You will find enclosed a copy of Service Bulletin S07LZ regarding the Power Distribution Unit (PDU) close out fasteners on 2004-08 model year Blue Bird "Vision" buses.

PDU Closeout Fasteners

MODELS AFFECTED: Certain 2004-2008 BBCV Visions

S07LZ

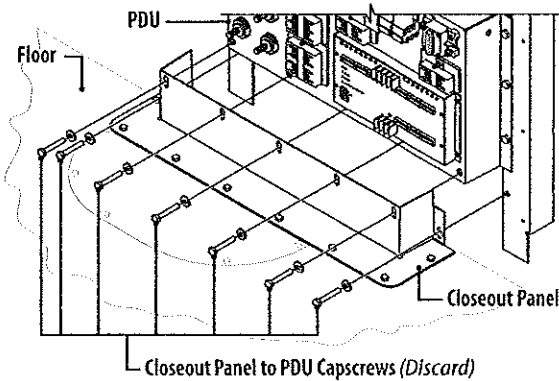
The fasteners used to attach the closeout panel to the Power Distribution Unit (PDU) may not be the correct length.

Remove the incorrect length fasteners and replace with the correct length fasteners.

- 1 Park vehicle on a level surface, apply parking brake, turn engine off, and remove ignition key.
- 2 Loosen two thumb screws and remove the PDU cover.
- 3 Remove and discard seven Closeout Panel to PDU capscrews.

- 4 Install seven new capscrews (0000610) with washers (2127173) provided for the Closeout Panel to the PDU.
- 5 Reinstall the PDU cover.
- 6 Return the bus to service.
